# MEMORANDUM

**FROM:** NOVATECH

**RE:** SOUTH STREET CONSENT APPLICATION – 1504107 ONTARIO INC – B-80-21

SITE PLAN

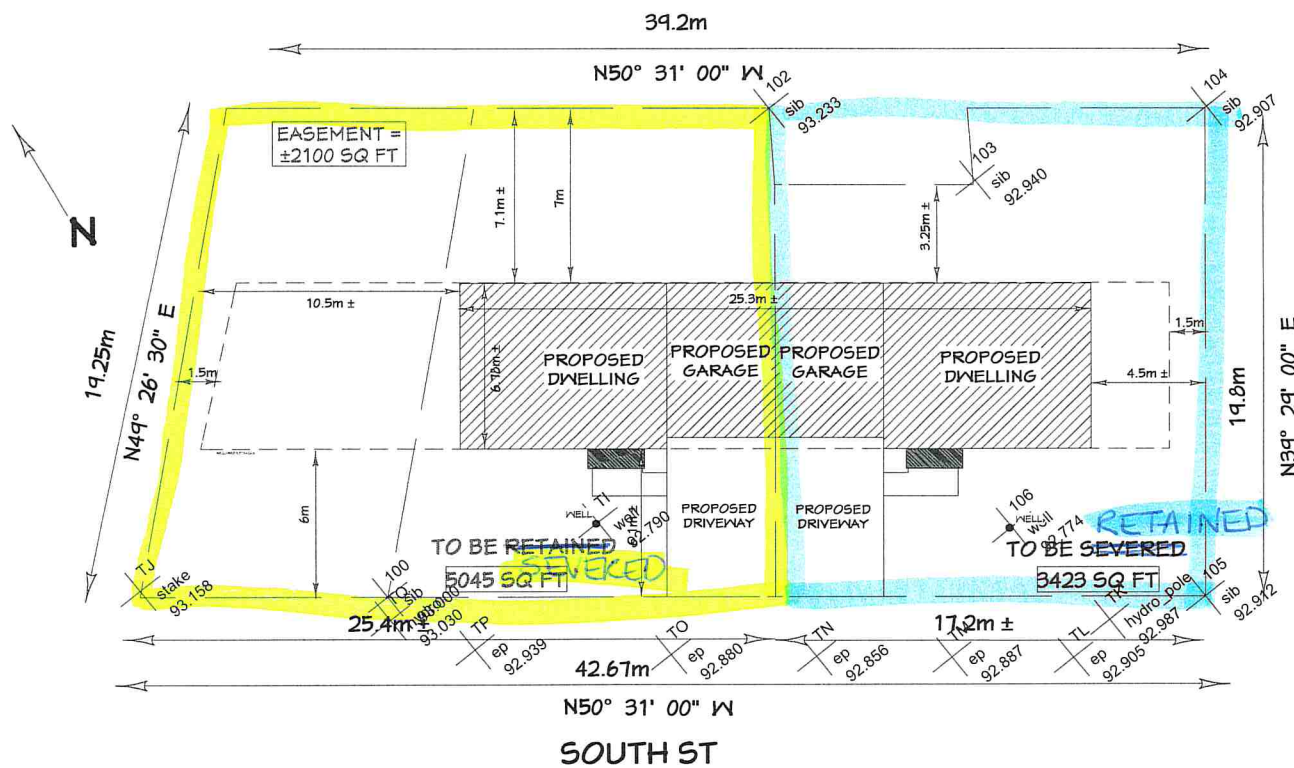
The subject lands are zoned R2 which permits a semi-detached dwelling. As demonstrated on the submitted site plan, the proposed dwelling will not meet the minimum rear yard setback for one of the proposed dwelling units (proposed retained lands). The rear yard setback cannot be met in this instance due to the configuration of the existing parcel. The R2 zone requires a minimum setback of 7 m whereas the proposed dwelling will be sited 3.25 m from this lot line. As such, relief from the Zoning By-law will be required to address the setback deficiency for the development as proposed.

The site plan submitted with the application demonstrates the remainder of the site can be developed in accordance with the R2 zone standards. Section 6.2(c)[iv] of the Township's Zoning By-law includes specific provisions with regards to severing a semi-detached dwelling to accommodate freehold ownership. While the proposed lot areas and frontages do not comply with the R2 zone standards, Section 6.2(c)[iv] contemplates the division of a parcel of land containing a semi-detached dwelling without the need for relief from lot area and frontage requirements. It is considered that the resulting lot coverage on the southerly lot would not require special zoning relief.

- 2) That the severance is approved to accommodate a proposed semi-detached dwelling, and that the applicant obtain relief from the provisions of the Zoning By-law, to the satisfaction of the Township, as necessary to provide zoning conformity for the proposed semi-detached dwelling.
- 3) That the applicant enter into a Development Agreement, to the satisfaction of the Township, to implement the recommendations of the Hydrogeological Study prepared by Morey Associates.
